### DEVELOPMENT ADVISORY UNIT

### TUESDAY, 7 MAY 2024

U24/0630 - TWO STOREY SINGLE HOUSE AT LOT 50 (NO. 59A) ROME ROAD, MI	ELVILLE
(REC) (ATTACHMENT)	4
U24/0631 - TWO STOREY GROUPED DWELLING AT LOT 1 - 1/15 SIMPSON S	STREET
APPLECROSS (REC) (ATTACHMENT)	14

Figure 2: Shows the maximum southern shadow generated (in green) onto the southern affected lot approved ground floor plan.

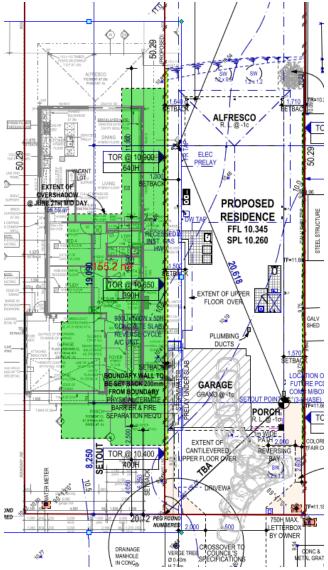
- There are two north facing major openings (See Figure 3 below) of the southern lot that are affected by the subject development. No other major openings or outdoor living areas are affected by the shadow. This southern affected dwelling has a finished floor level (FFL) of 11.05. The subject site has an FFL of 10.345, in this regard the shadow cast onto the southern property will be minimised due to dwelling floor level and natural ground level differences. The 0.7m difference in FFL, with the affected southern site higher, minimises the length of the shadow cast to these major openings at midwinter. This is also the single storey element of the subject dwelling that is casting this shadow to these openings, further minimising potential amenity and access to light/ventilation impacts.
- No existing solar collectors are affected by the shade cast.

Figure 4 – Plan of Adjoining Western Property Confirming That Subject Boundary Wall abuts an Adjoining Carport

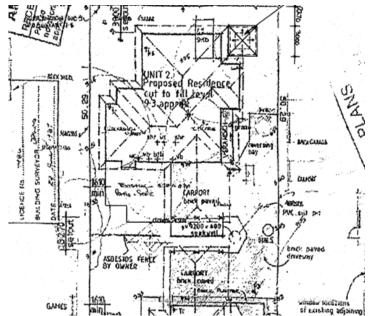
- The wall height discretion sought is considered to be minor and to not have adverse impact on the amenity of the adjoining dwelling. Neighboring major openings are not impacted by the boundary wall through their setback from the boundary and orientation of the subject wall abutting the adjoining properties carport for a considerable portion of its length. Refer to Figures 3 & 4 below.

Figure 6 – Rear First Floor Articulation to Mitigate Bulk

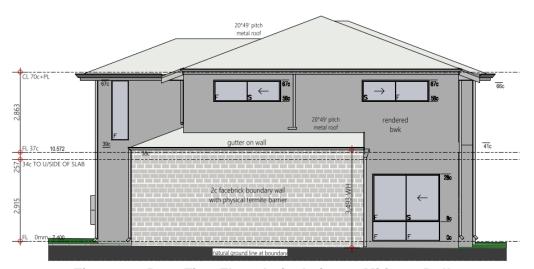
- Proposed reduced setback of the required 6m from rear (western boundary) allows the subject dwelling a northern aspect for its outdoor living area located adjacent to Simpson Street. The outdoor living areas proposed location allows for the site to maximize its lot size for both building and outdoor exploits in a way that maintains consistency with the planning considerations of grouped dwellings zoned R15 in the immediate area and surrounds. Refer to Figure 5 below.
- The rear (western) elevation will not have a bulk impact due to the use of articulation via use of differing materials, setbacks on both levels and window openings. Refer to Figure 6 below.
- Solar access is compliant with the deemed to comply provisions of the R-Codes for the adjoining western property.
- No overlooking issues will result from both walls.

Figure 7 – Proposed Upper Floor Plan with Setbacks to Southern Property to Left of Image

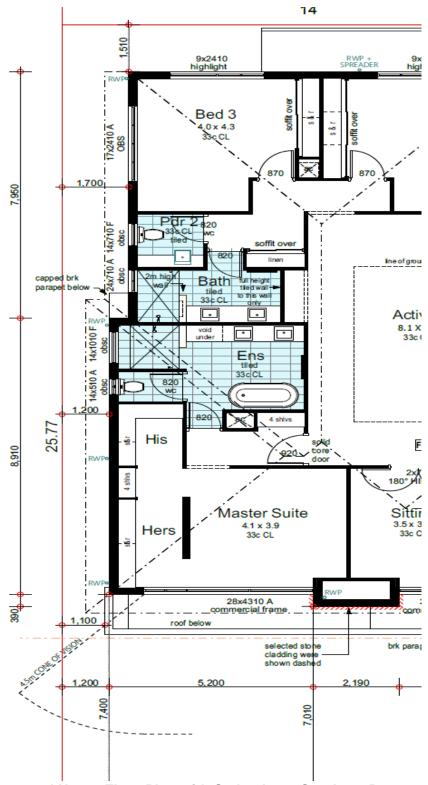
- Building bulk is reduced through articulations along the southern boundary via two
  differing wall setbacks along the upper floor as well as numerous window openings
  which are either obscure or transparent. Refer to Figure 7 below.

Figure 9 – View looking south towards adjoining southern property where subject wall would face

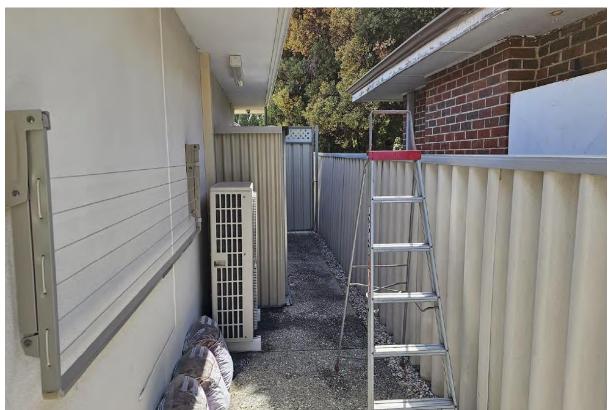
- The proposed wall abuts a single storey single house which on its northern elevation facing the subject site, has walls with no major openings and not abutting an outdoor living area. Refer to Figures 8 & 9 below.
